CITY OF LA VISTA
PLANNING COMMISSION

STAFF REPORT

PRELIMINARY PLANNED UNIT DEVELOPMENT (PUD)
CIMARRON TERRACE APARTMENTS

May 21, 2009

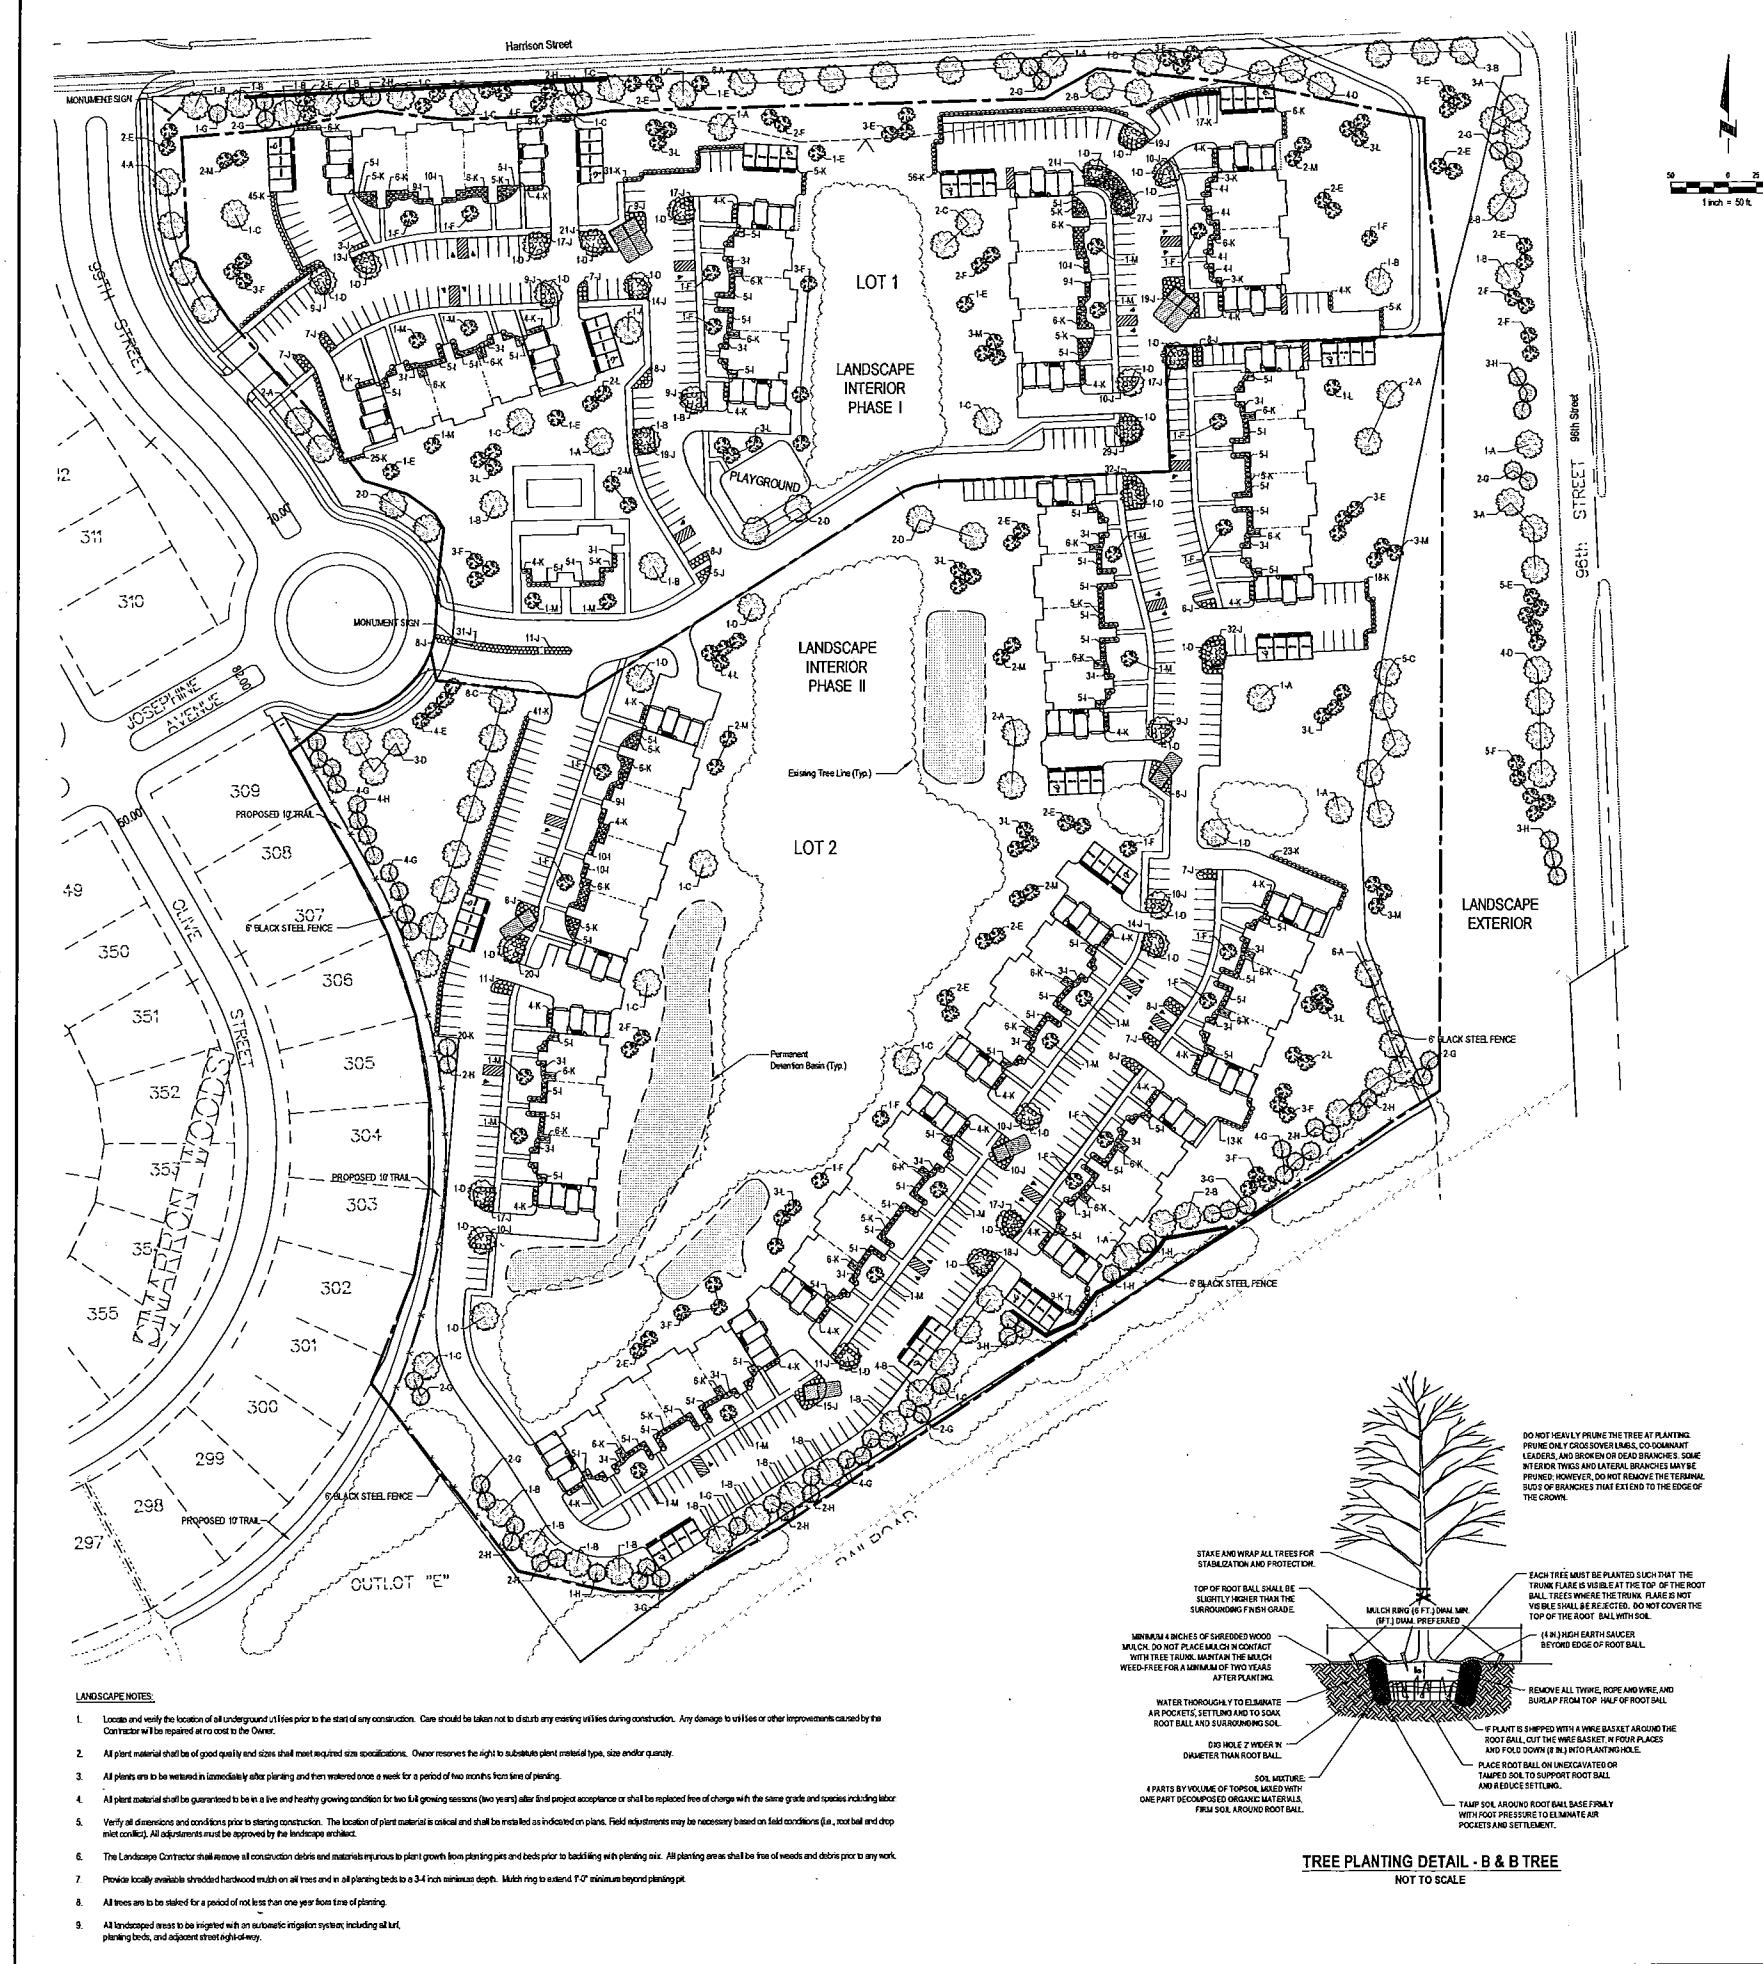
2. Heights need to be shown for all buildings, including detached garages, so that compliance with height restrictions can be determined.
3. Carports will not be compliant with design review regulations; therefore, this label should be removed from all plans.

4. The Preliminary PUD plan needs to show proposed utility and access easements. The access easement would assure ingress/egress in case Lot 2 is bought by a different owner in the future.

5. A break or gate needs to be provided in the fence to access the pedestrian trail on the Westside of the property. Preferably, the gate should be at a convenient and accessible location to the apartment buildings 7 and 14.

Some of the dumpster locations and parking areas may need further review to ensure good traffic maneuverability and access to buildings. For example, the parking area to the South of building 8 and to the East of the garages appears inconvenient and unneeded. Also, the parking area to the North of building 9 and to the West of the garages could also be eliminated.

1. The Preliminary PUD Plan and application refers to the property as being zoned R-1 (PUD). This needs to be revised on the Final PUD Plan to read R-3, PUD-1 zoning.

POST CONSTRUCTION WATER QUALITY EXHIBIT

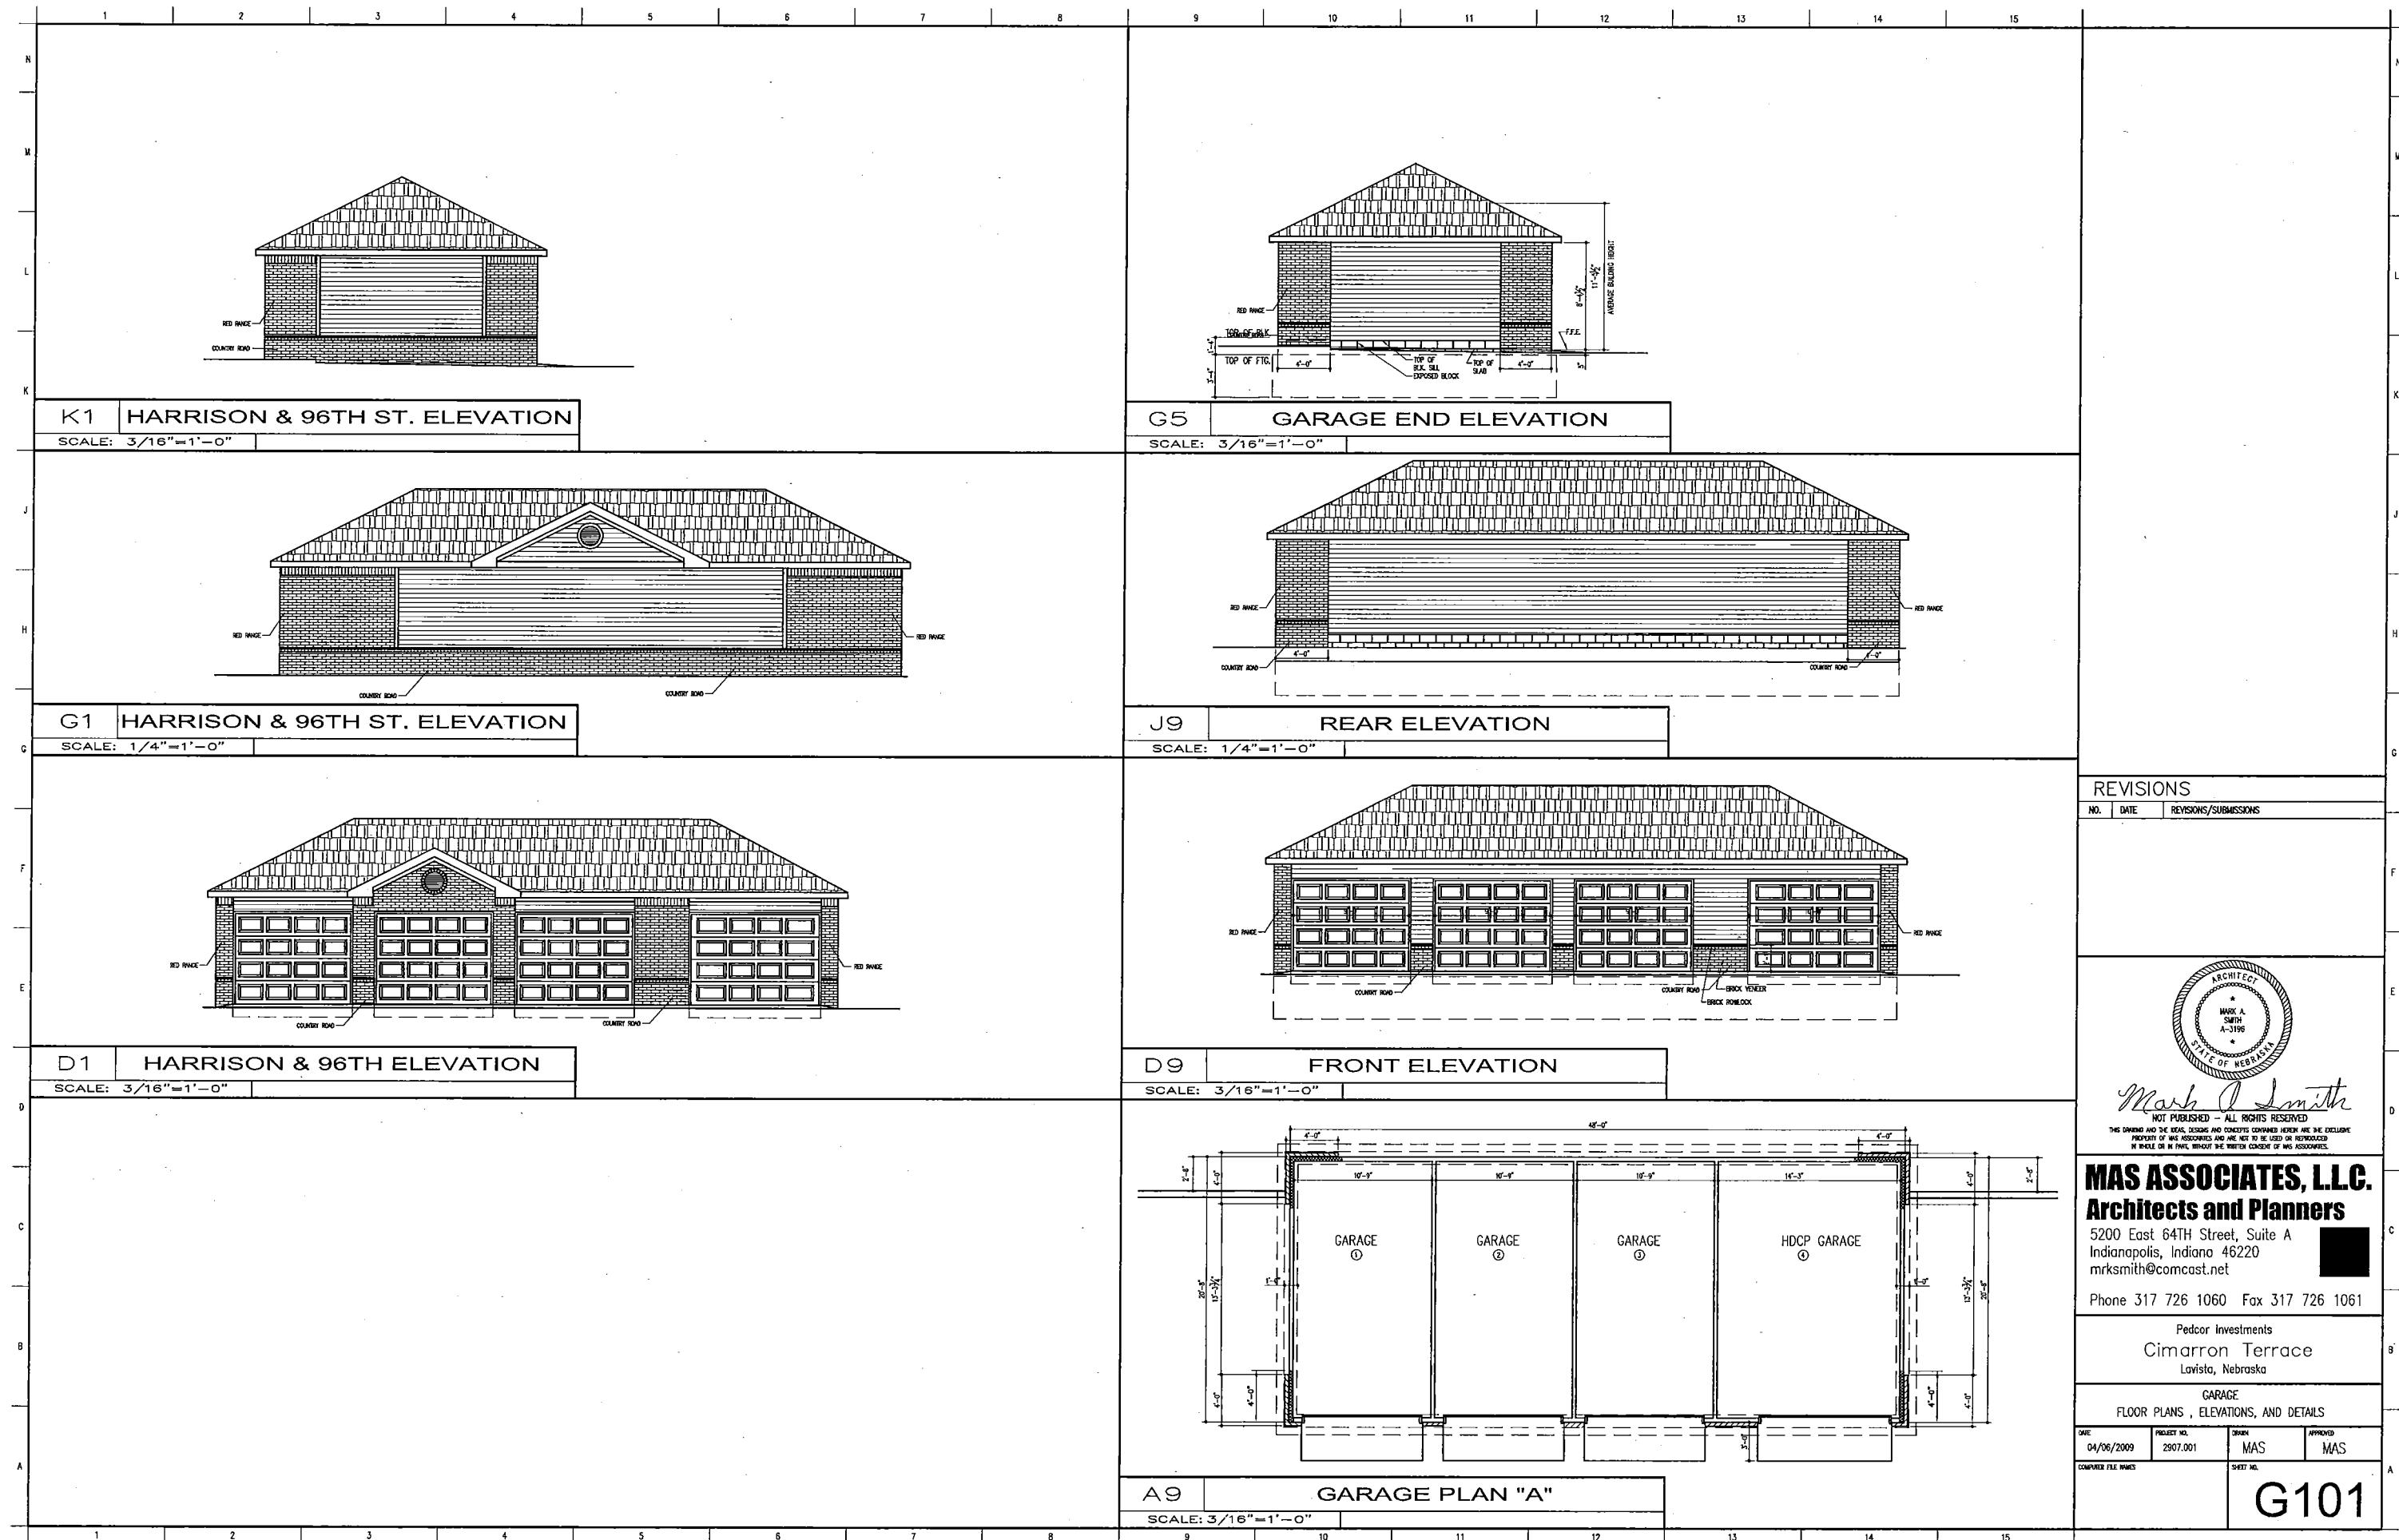
6. A preliminary drainage study is currently under review, including the Post Construction Water Quality Exhibit. These were submitted May 12th.
7. A traffic signal will need to be installed at 99th and Harrison Street, as per the original subdivision agreement for Cimarron Woods Subdivision.

CLUBHOUSE EXTERIOR
ELEVATIONS

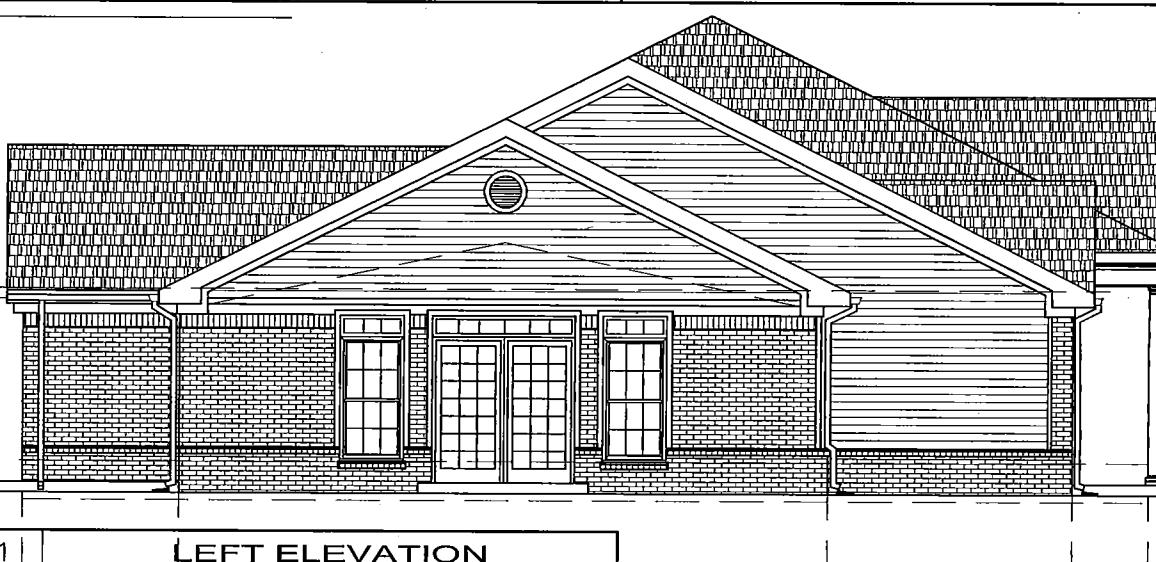
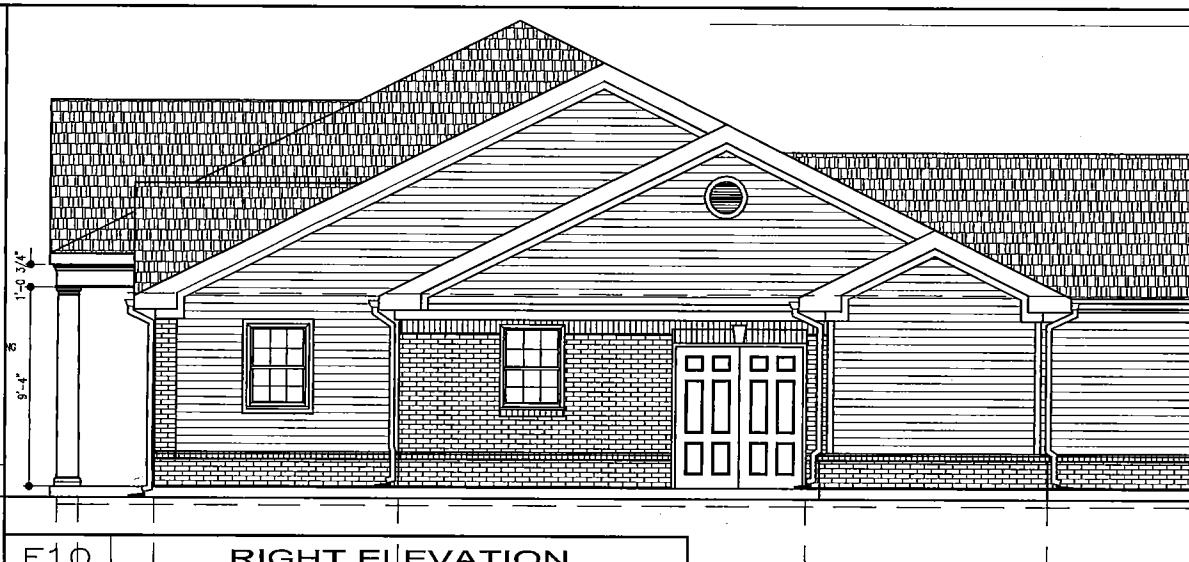
3. Elevation drawings of the clubhouse need to be reviewed for compliance. These were not submitted with the original design review application; however, these drawings were submitted May 12th and are now under review.
